Stage 2 Development Special Use Permit #2017-0023
Encroachment #2018-0002
2410 & 2460 Mill Road – Hoffman Blocks 4 & 5

Purpose of Application
The Applicant requests Stage II approval of a Development Special Use Permit in order to construct a mixed-use residential and retail complex with 721 dwelling units, grocery store and other retail uses, parking, and associated site improvements.
Special Use Permits and Modifications Requested:
<ol style="list-style-type: none">1. Stage 2 Development Special Use Permit (DSUP#2017-0023) with site plan to construct a mixed-use retail and residential complex.2. An Encroachment (ENC#2018-0002) for residential balconies and other architectural features to extend up to 5'-1" into the public right-of-way.3. A Special Use Permit to increase the number and height of penthouses.4. A Modification of the vision clearance requirement at one intersection.5. A Modification of the crown coverage requirement pertaining to tree canopy.
Staff Recommendation: APPROVAL WITH CONDITIONS
Staff Reviewers: Rob Kerns, AICP, Development Division Chief rob.kerns@alexandriava.gov Gary Wagner, RLA; Principal Planner gary.wagner@alexandriava.gov Nathan Imm, Principal Plann

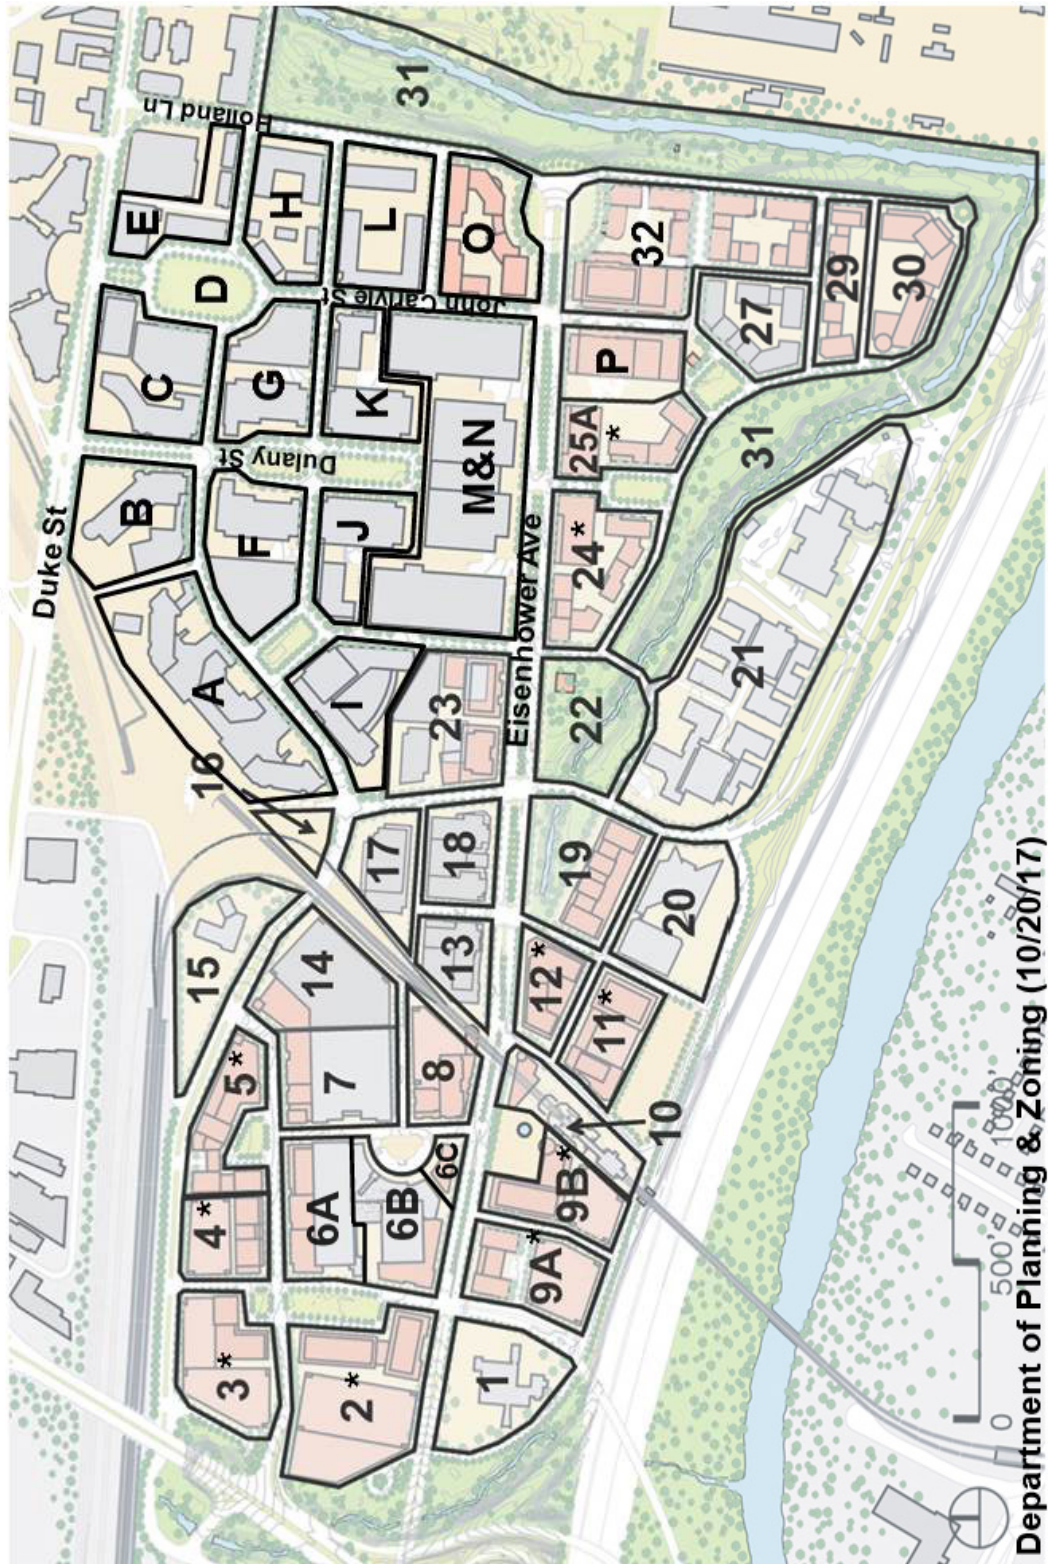
7. The plaza at the north side of the intersection of Swamp Fox and Mandeville is a space that was designated in the Small Area Plan for Eisenhower East as a critical aspect to create a vital town center. City Staff have included conditions for further design of the plaza space to ensure that it will succeed as a public space amenity for the neighborhood. In its current design, there are three areas of concern that remain: the perceived boundary between pedestrian plaza and vehicular space; the lack of three-dimensional differentiation within the plaza, and the further development of the plaza's focal water feature.

8. Pedestrian/Vehicular Boundary: The extension of the pavement design into the intersection provides an attractive invitation into the plaza space. However, from the inside of the plaza looking outward to the incoming traffic, the slim boundary of bollards will result in an uncomfortable feel for plaza users. In order to maximize the usable and desirable area of the plaza, a condition is provided that the Applicant continue to work with Staff to enhance the boundary to provide a feeling of security to plaza users while maintaining the permeability of the edge.

9. Three-Dimensional Design: At 14,000 square feet, the plaza is a significant urban open space. Variation of the ground plane to provide three-dimensional differentiation between use area,

features, and others will serve to bring the plaza to a human-scale, enhancing its utility and aesthetics.

10. Focal Feature: A focal feature of public art and a water feature is centered on the plaza and Swamp Fox centerline. In its current iteration, the focal feature is displayed as a basic geometric shape. As this focal feature will contribute significantly to the character of the plaza, the Applicant is conditioned to work with Staff to enrich this feature. The conditions for the plaza are intended to provide flexibility in the design solutions for these few remaining issues as the Applicant works with Staff through their resolution in Final Site Plan.

- c. The Applicant shall work with Staff to vary the three-dimensional design of the plaza to address the appearance of an unrelieved plane, and; resolve the plaza edge design to retain the visual connectivity of the intersection and the plaza while enhancing the perception of security for the plaza users, to the satisfaction of the Director of Planning & Zoning.

Attachment 5: Corner Vision Clearance Modification Exhibit

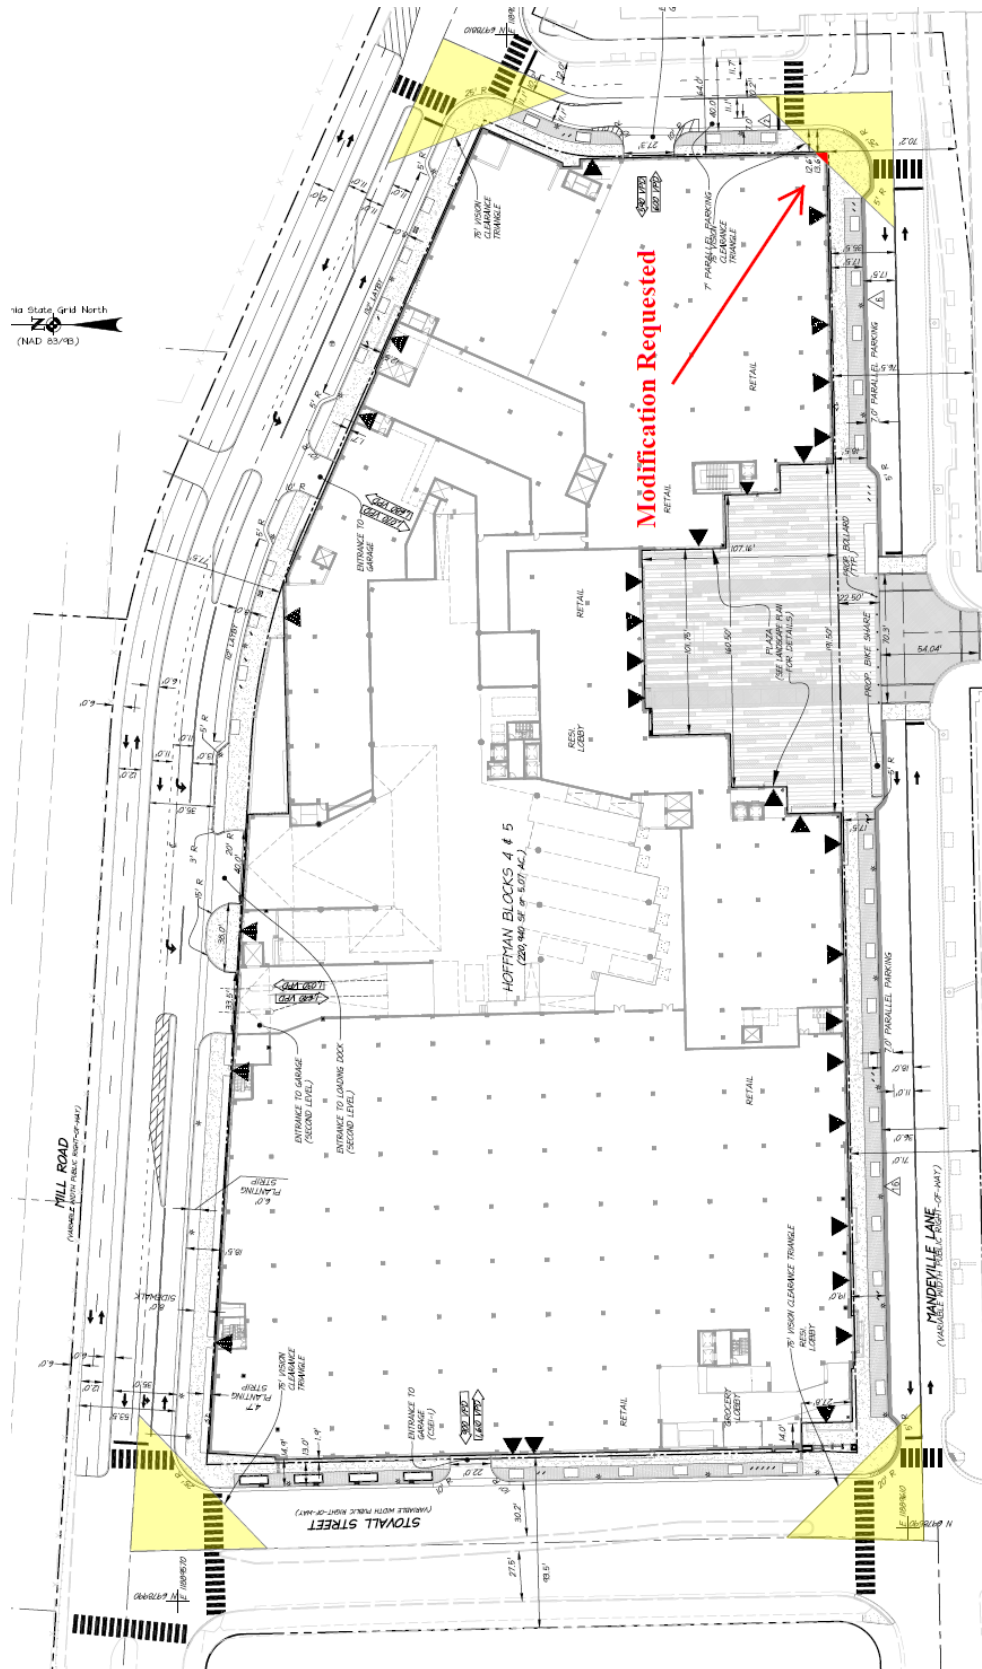
Of the four corners associated with this site, three comply with the vision clearance requirement (*Attachment 5*). The corner of Mandeville Lane and its northern extension is the site of the modification request. The vision triangle consists of approximate 68-foot sides, meaning about four feet of each building wall from the corner falls within the 75-foot triangle. Staff supports this request, finding that the modification of the vision clearance requirement is slight at only seven feet less than required and would only occur at one intersection. Furthermore, the modification is not undesirable, given that the proposed building would be close to the street, supporting the general urban development pattern recommend by the Eisenhower East Small Area Plan.
